DATE: APRIL 2, 2025
TO: ALL CONTRACTORS
FROM: DUSTIN TILL, P.E.
PROJECT: COUNTY ROAD 29 WATER TREATMENT PLANT
PRATTVILLE WATER WORKS BOARD
GMC PROJECT NO. CMGM230095
RE: ADDENDUM #1

ADDENDUM NUMBER 1

COUNTY ROAD 29 WATER TREATMENT PLANT

GMC PROJECT NO. CMGM230095

C-901

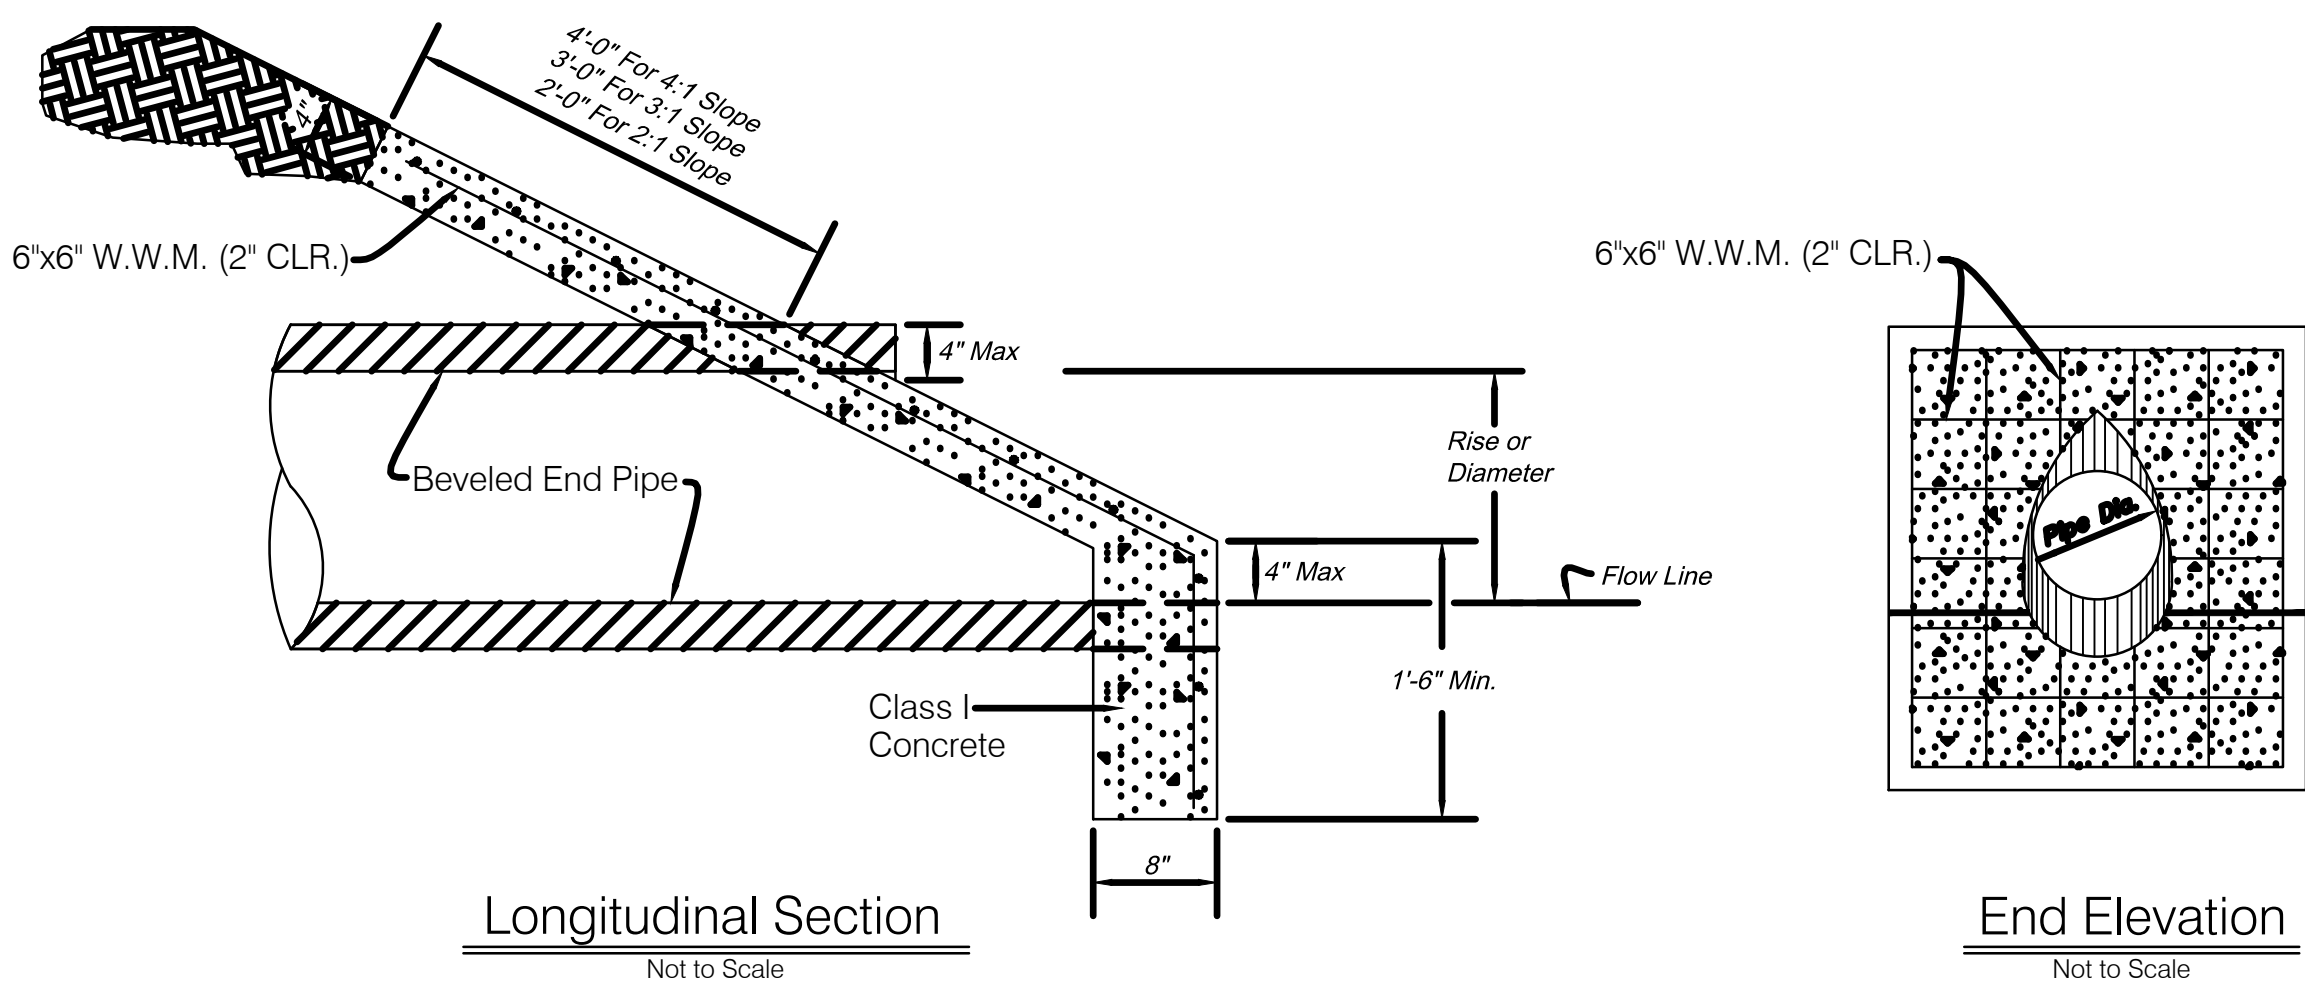
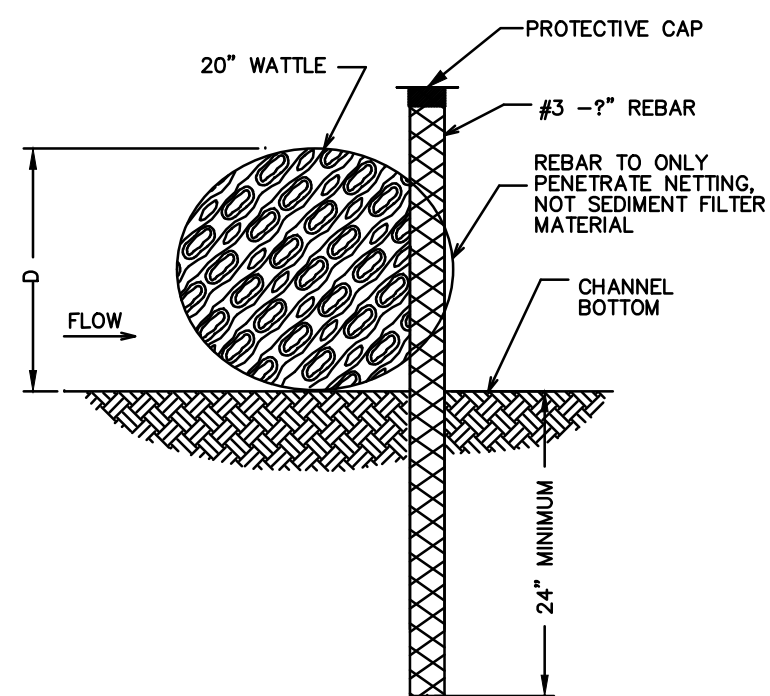
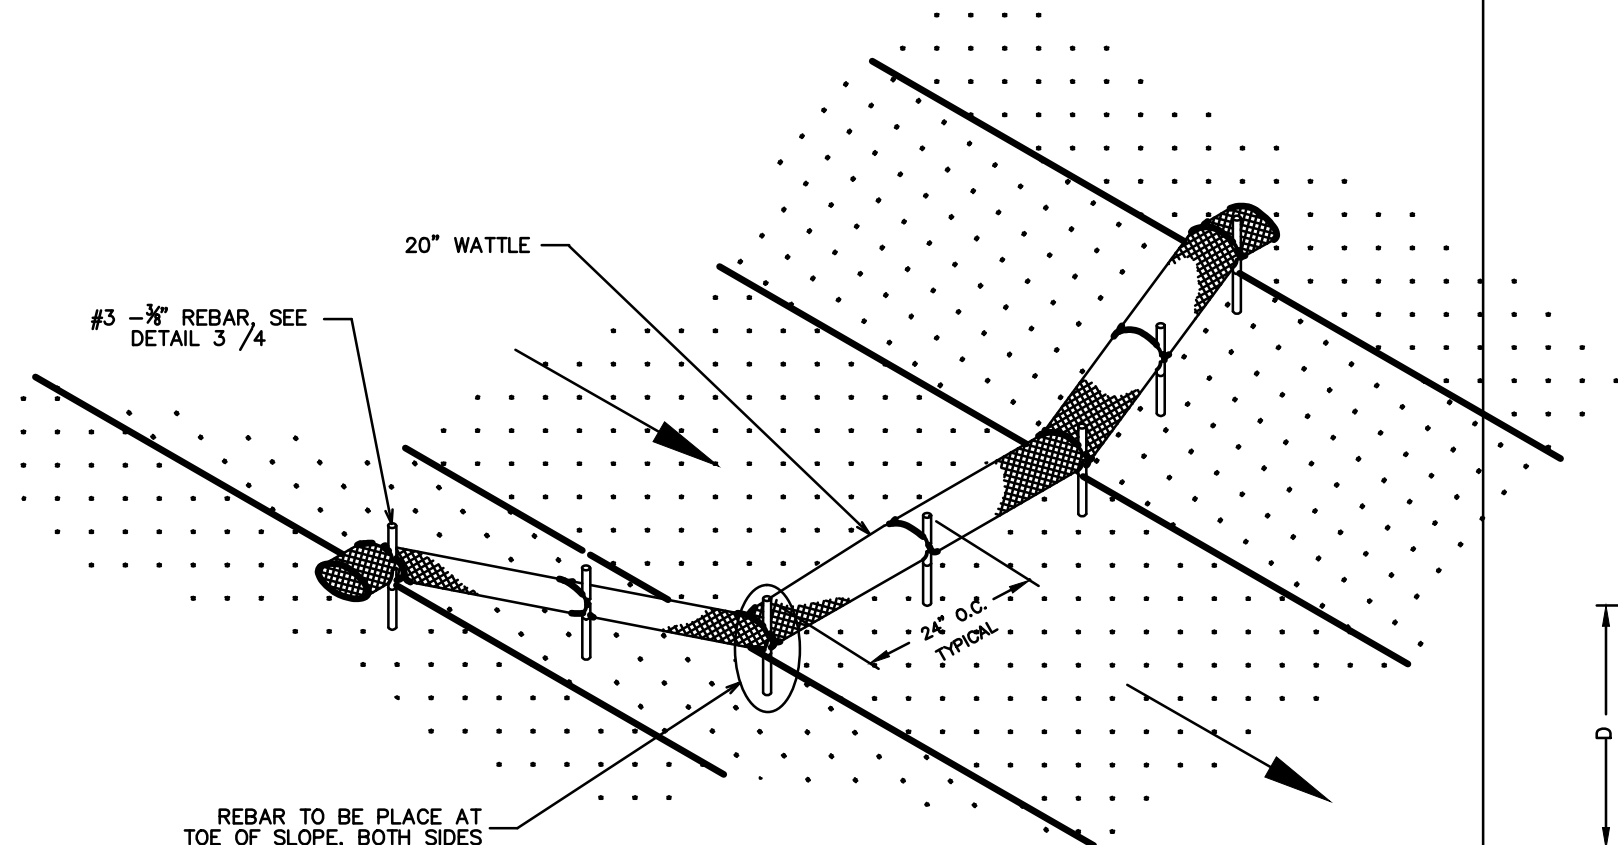
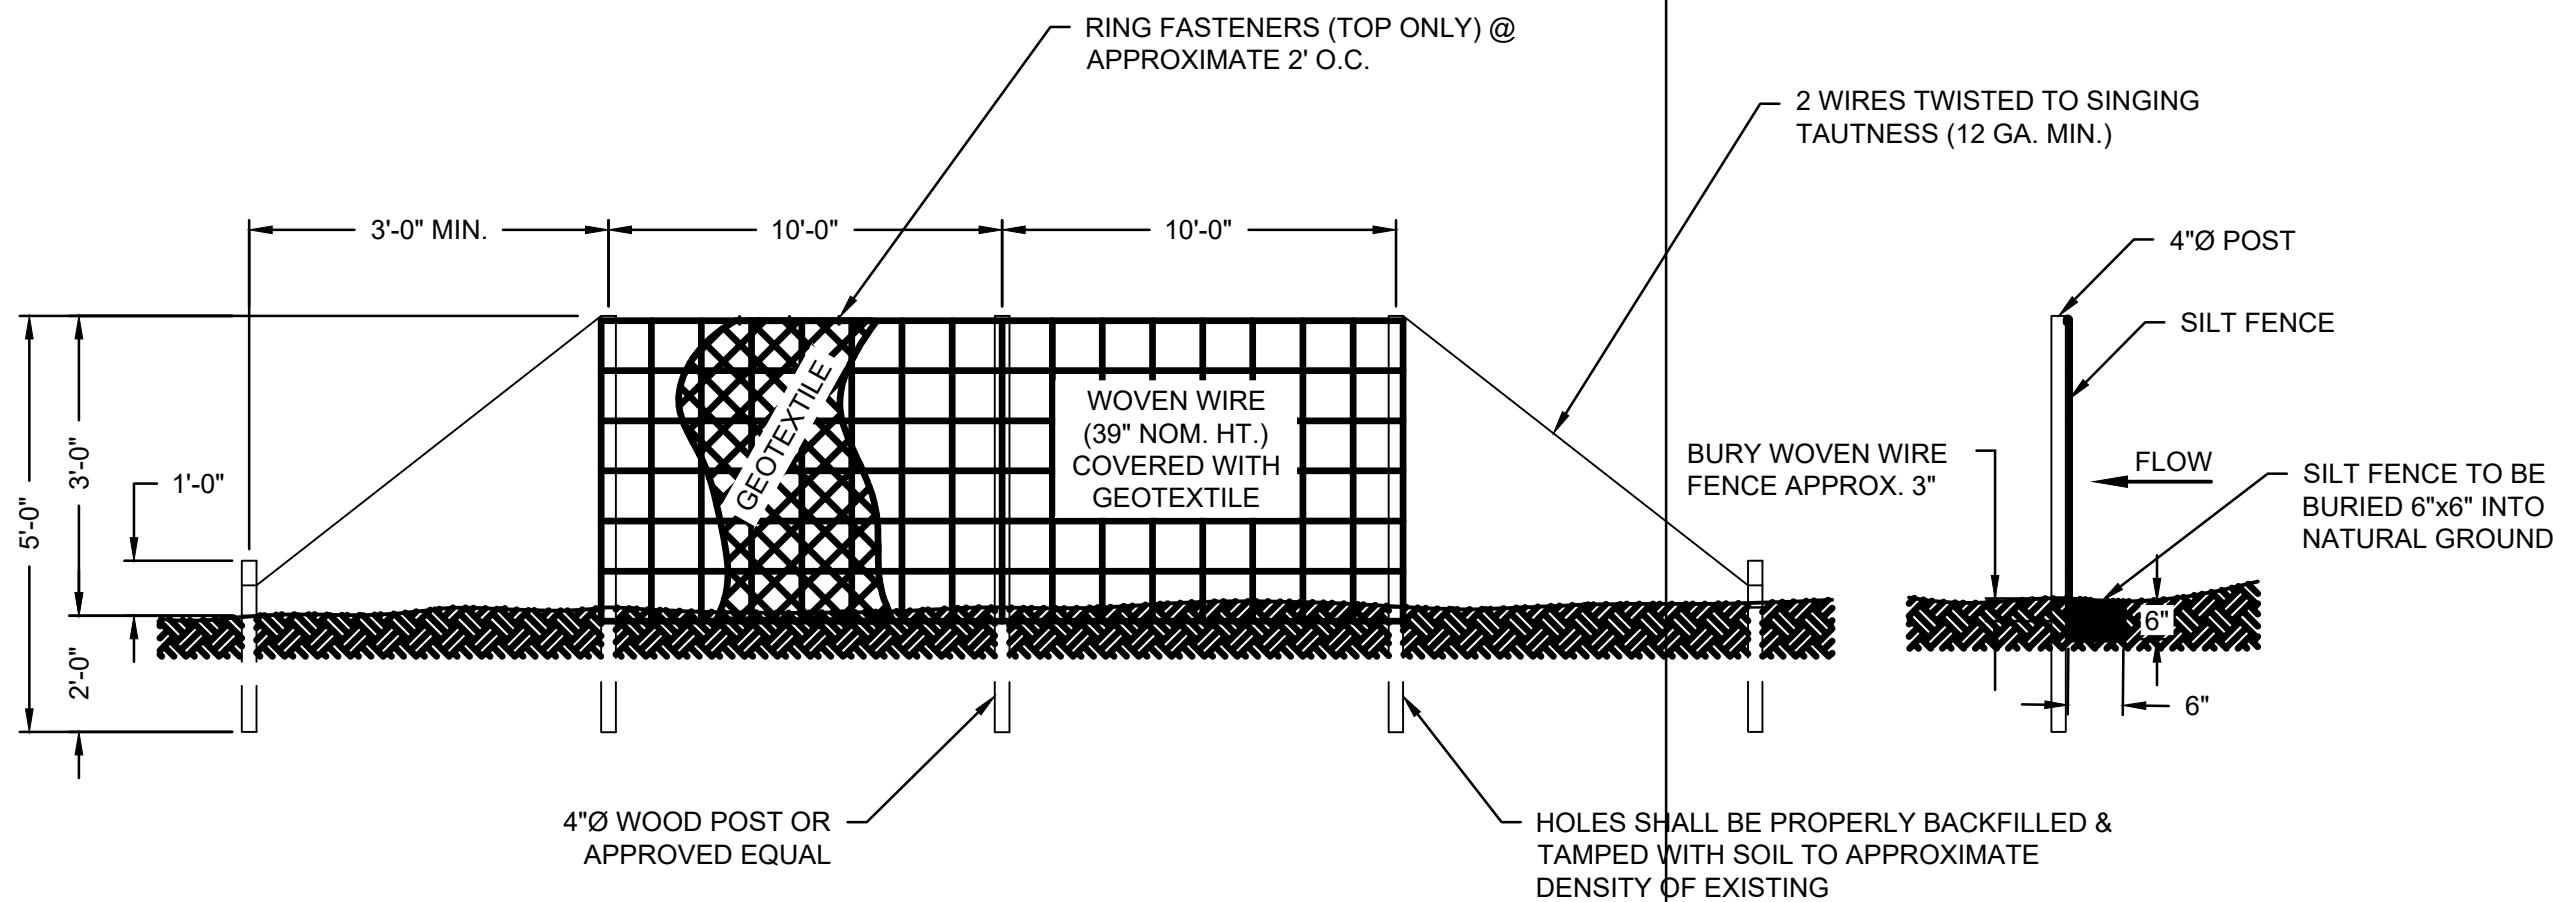
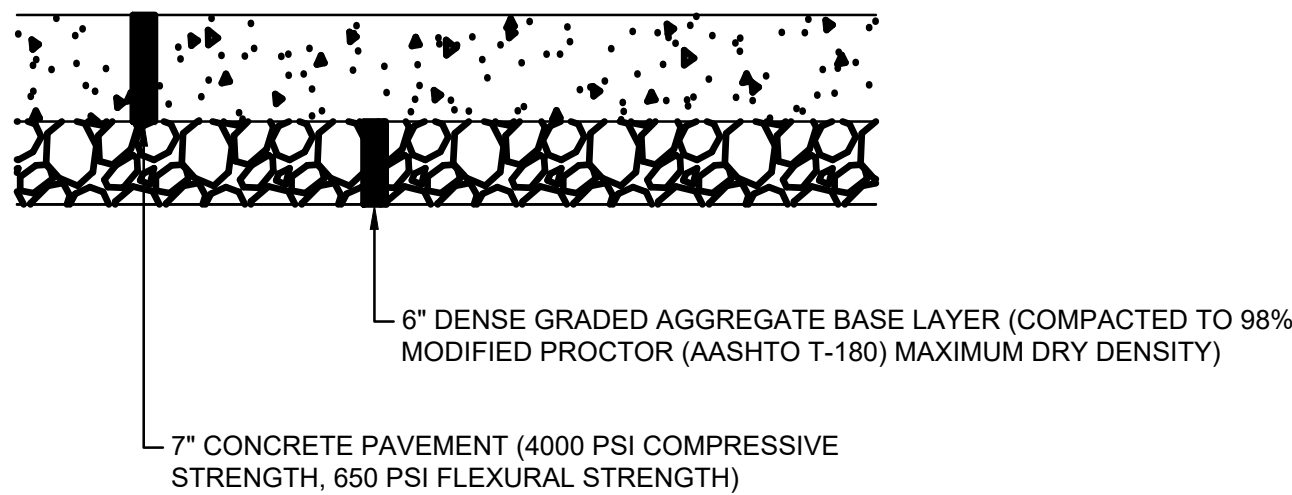
- 2.1 ACI is an approved manufacturer for the Pre-Engineered Metal Building.
- 2.2 The electrical, mechanical and plumbing drawings have been revised and are included as an attachment to this addendum. Revisions are clouded.
- 2.3 C-901 has been revised to include a concrete paving detail.

Answer: The chemical pull boxes shall be minimum 18" wide x 24" long plastic valve box.
- 4.12 **Question: Sheet C-211 states see sheet C-901 for details of the concrete paving; however, it does not show up on sheet C-901 or any other sheet, please provide a detail for the concrete paving required on the project**

Answer: A concrete paving detail has been added to C-901. The revised sheet is included as an attachment to this addendum.
- 4.13 **Question: Please approve Foley Products as an equal for the Flat Grate Inlets on the project.**
